RPA450 Technical Detail

PRODUCT IMPROVEMENT

RPB, RPA and RPC Commercial Two Speed Coolers

WALL SWITCH

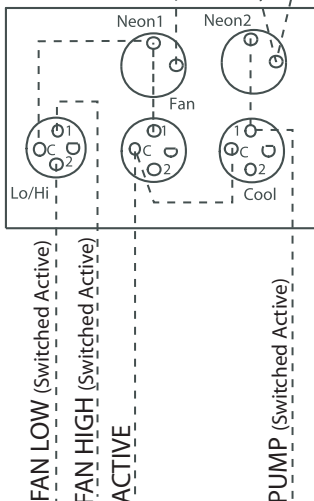
Due to pending changes in some state safety regulations, as well as energy management becoming increasingly important to all Australian business Braemar Commercial 2 speed wall switches will now come standard with 2 Green Neon Indicators.

The individual neon's on the wall switch will illuminate to indicate when either the pump (cool) or the fan motor (fan) has been switched on. This will allow office and factory personnel to identify at a glance if the Coolers fan or pump are running.

All coolers manufactured from Serial Number C0902xxxx will have the new wall switch included.

Required wiring from the cooler control box to the wall switch.

- Active x 1
- Switched Active x 3
- Neutral x 1

3 PHASE WIRING DIAGRAM

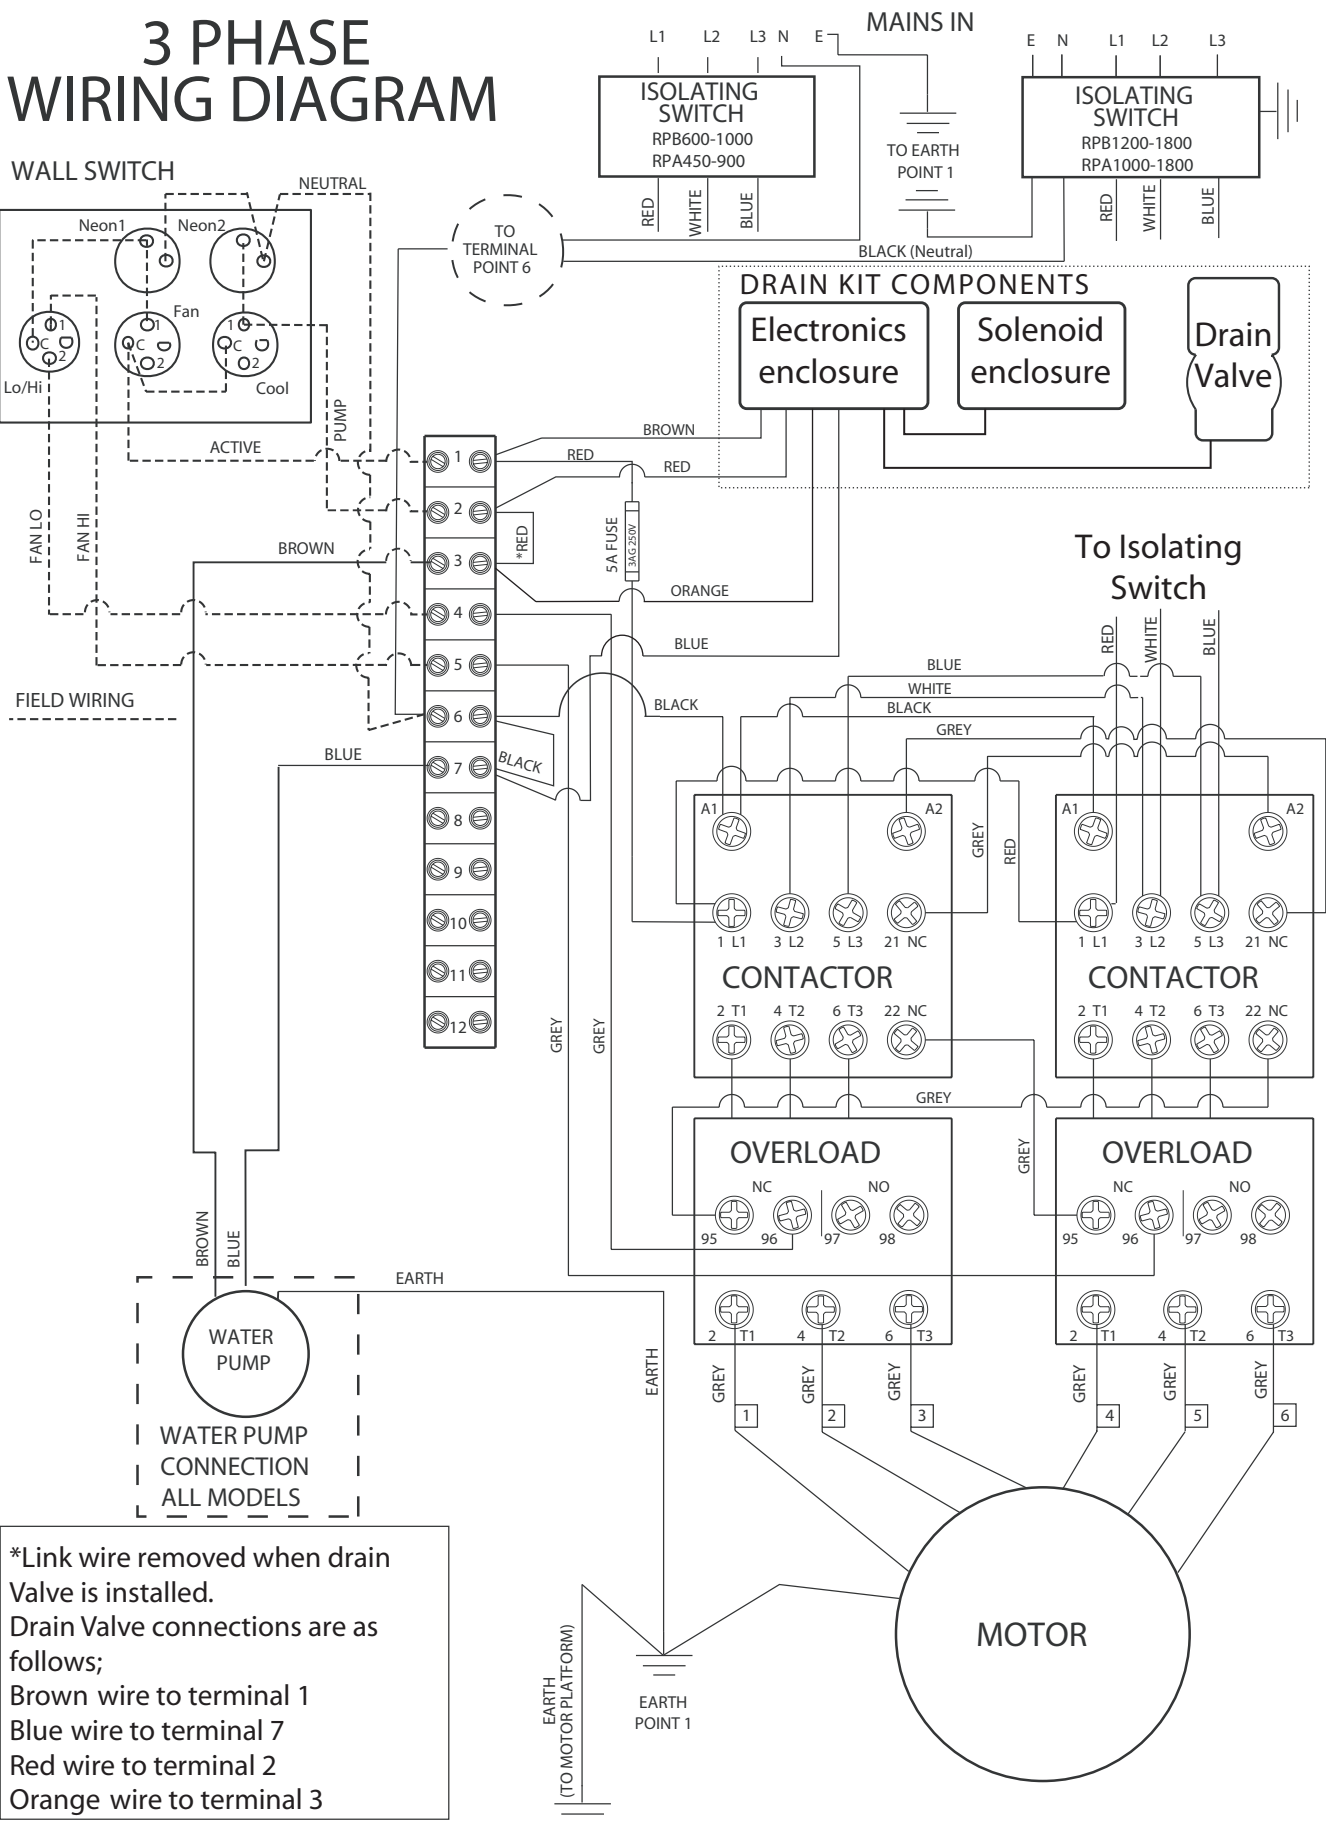
**THESE WIRING INSTRUCTIONS FOR UNITS MADE FROM MARCH 2009
AFTER THE INTRODUCTION OF NEON INDICATORS**

*Link wire removed when drain Valve is installed.
Drain Valve connections are as follows;
Brown wire to terminal 1
Blue wire to terminal 7
Red wire to terminal 2
Orange wire to terminal 3
